DISCRETIONARY REVIEW ABBREVIATED ANALYSIS

Record No.:	**2017-013947DRP**
Project Address:	**310 Green Street**
Permit Applications:	2017.1020.1807(expired) & 2021.0630.3516
Zoning:	RM-1 [Residential Mixed-Low Density] 40-X Height and Bulk District Telegraph Hill – NB Residential
Block/Lot:	0114/ 015
Project Sponsor:	Peter Ziblatt Pelosi Ziblatt Law Group 224 Kearny Street 9th floor San Francisco, CA 94108
Staff Contact:	David Winslow – (628) 652-7335 david.winslow@sfgov.org

Recommendation: Take DR and Approve with Modifications

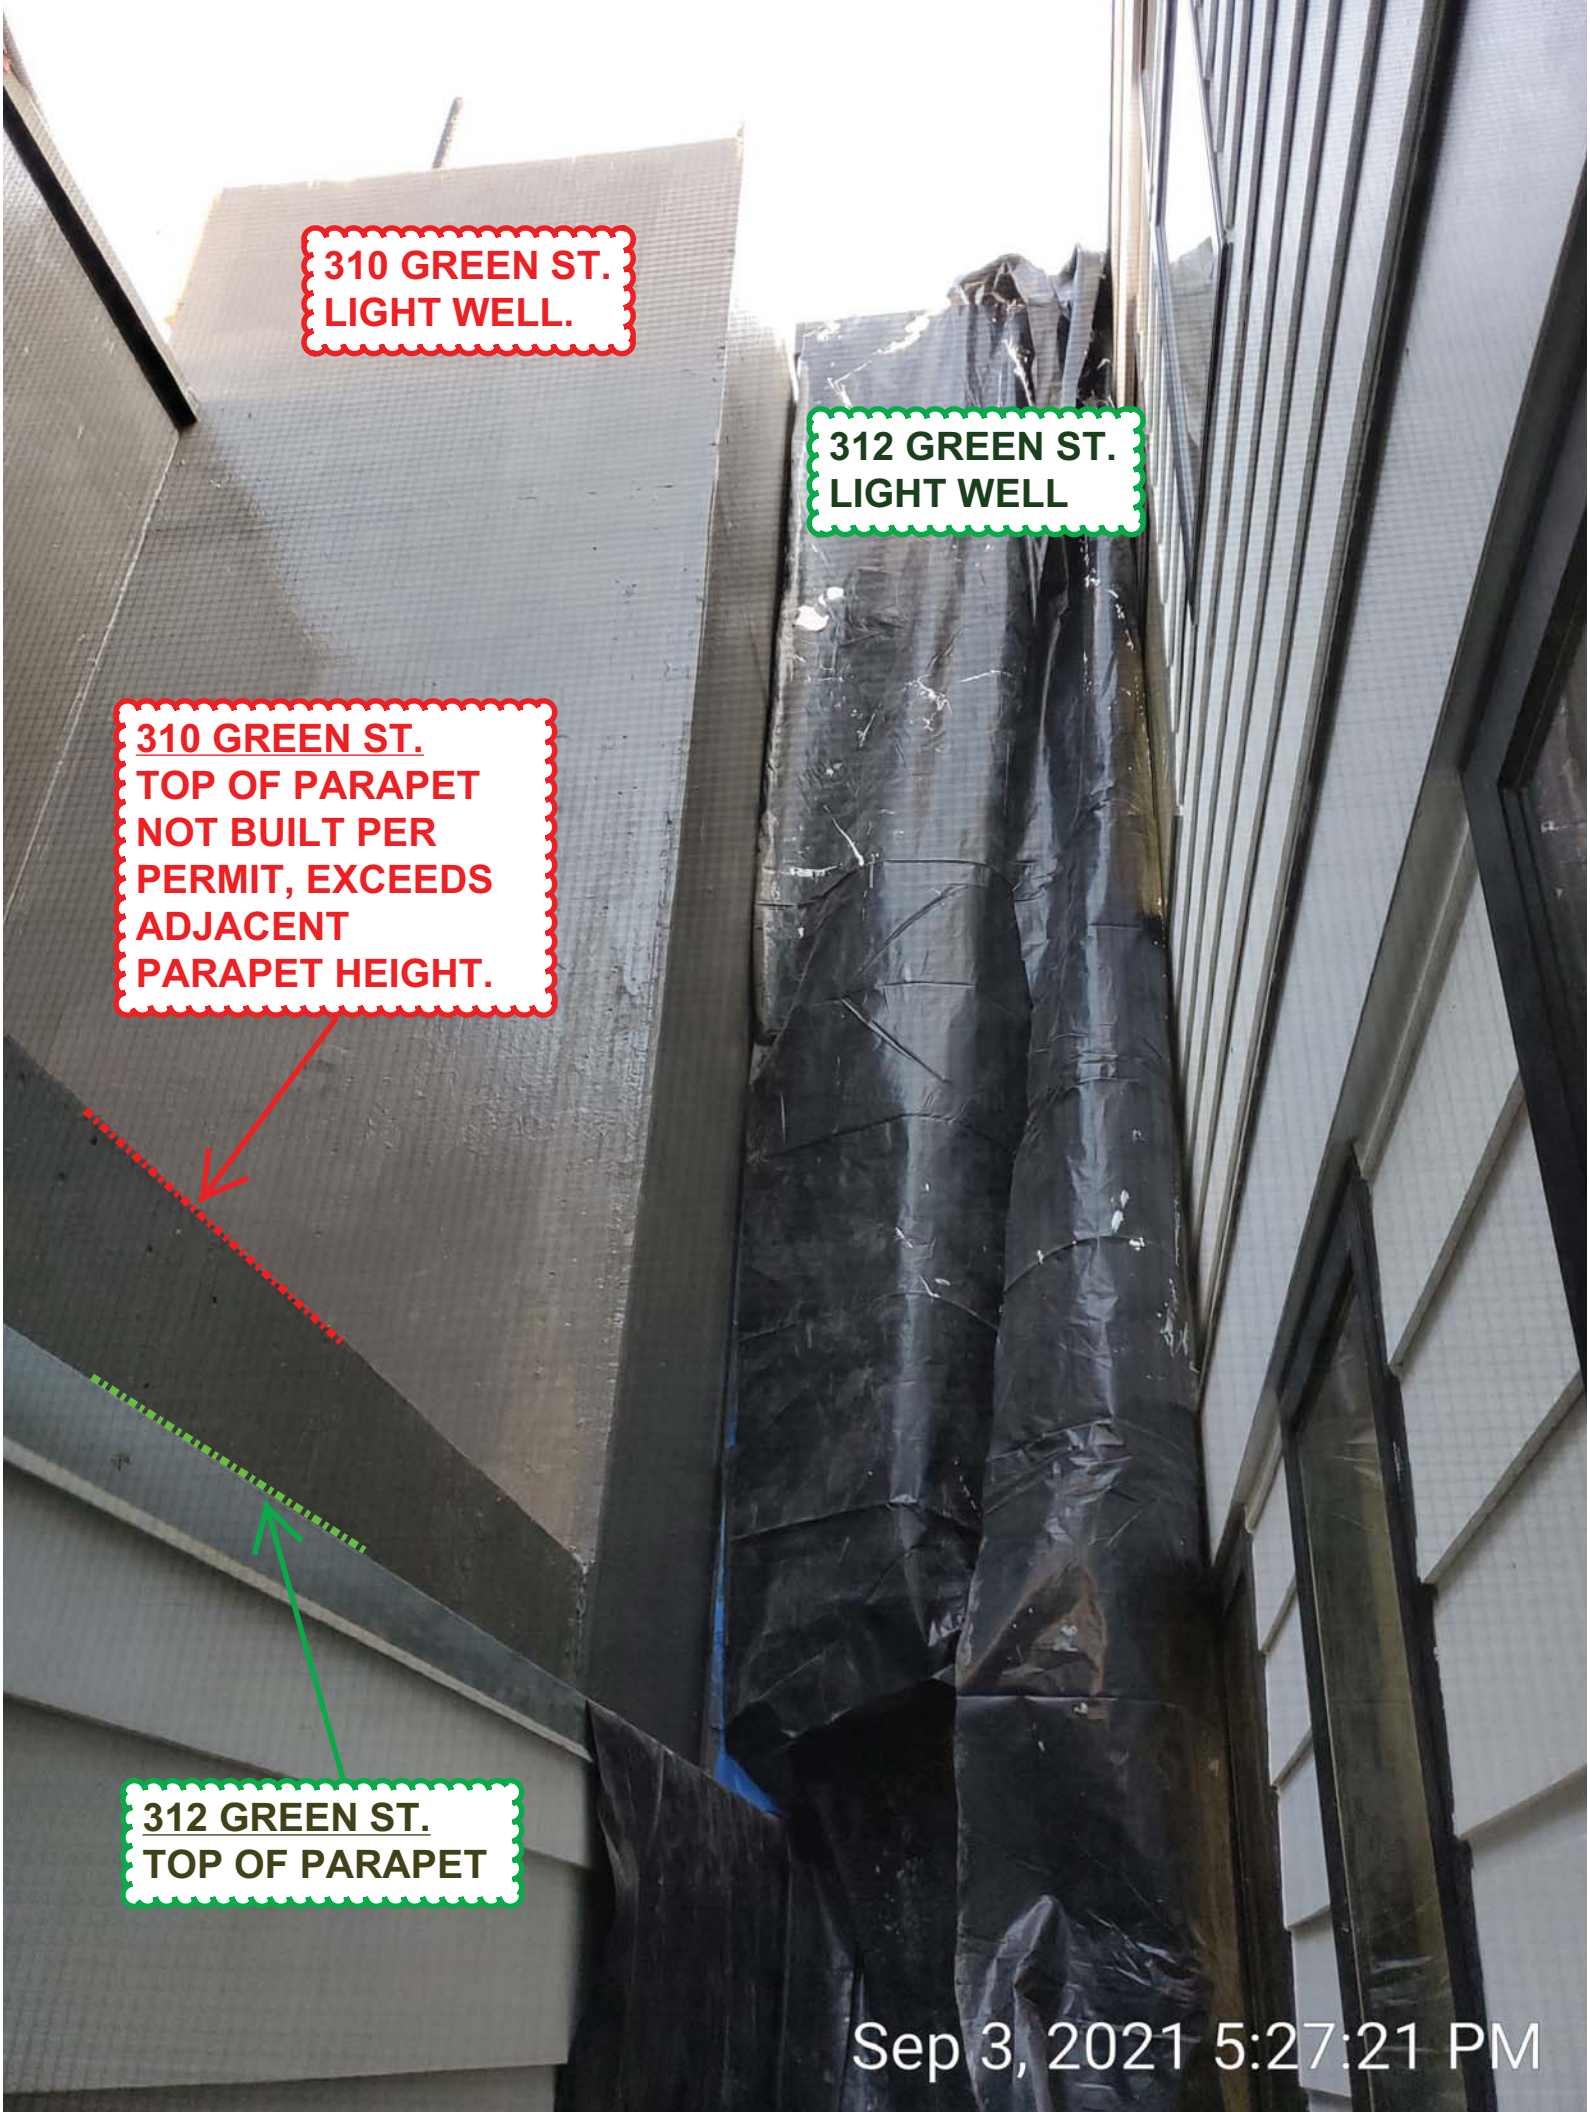
310 GREEN ST.
LIGHT WELL.
312 GREEN ST.
LIGHT WELL
310 GREEN ST.
TOP OF PARAPET
NOT BUILT PER
PERMIT, EXCEEDS
ADJACENT
PARAPET HEIGHT.
312 GREEN ST.
TOP OF PARAPET
Sep 3, 2021 5:27:21 PM
